V2500-A1/A5 SERIES PROPULSION SYSTEMS NON-MODIFICATION SERVICE BULLETIN

This document transmits Revision 1 to Service Bulletin EV2500-72-0543 and Revision 1 to the Supplement

V2500-ENG-72-0543

R ENGINE – REPLACEMENT OF PN 2A2493-01 NUMBER 4 BEARING COMPARTMENT OIL PRESSURE TUBES
– NON-MODIFICATION SERVICE BULLETIN

LOCATION OF THE NO. 4 BEARING PRESSURE TUBE ASSEMBLY
Figure 1

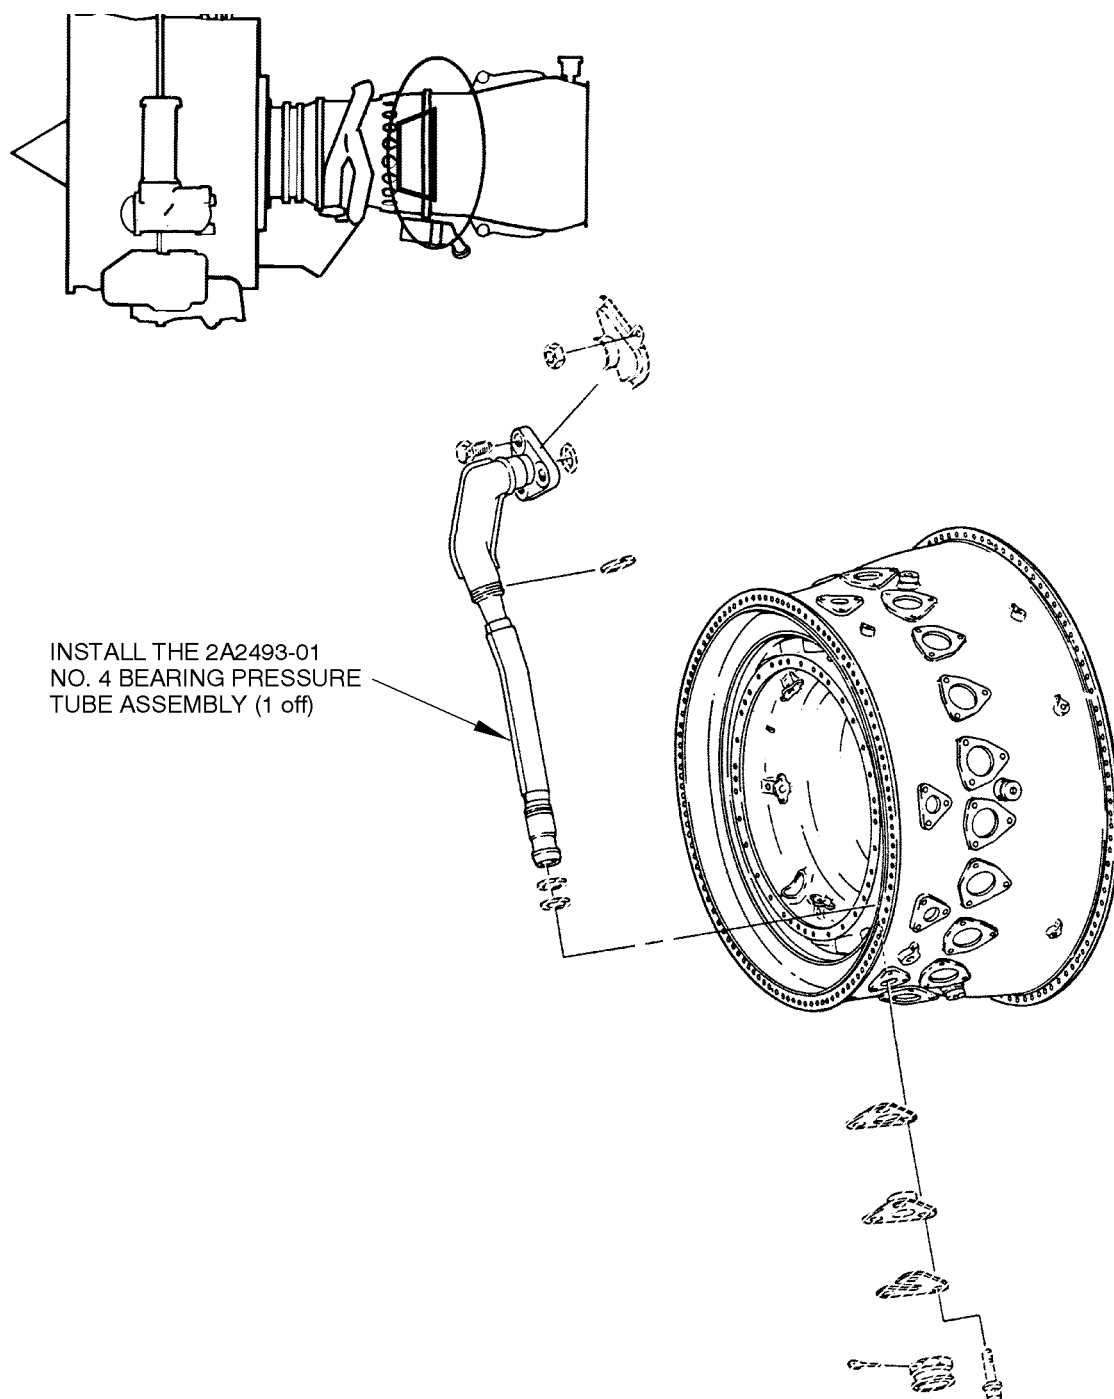
- (1) Disassemble the engine sufficiently to remove the No. 4 Bearing Oil Pressure Tube. Refer to Engine Manual Section 72-42-00, Disassembly.
- (2) Replace PN 2A2493-01 No. 4 Bearing Oil Pressure Tube with a new PN 2A2493-01 No. 4 Bearing Oil Pressure Tube. Refer to Figure 1
- (3) Assemble the engine per the Engine Manual Reference 3, Chapter Section 72-42-00, Assembly.
- (4) Recording Instructions
 - (a) A record of accomplishment is required.
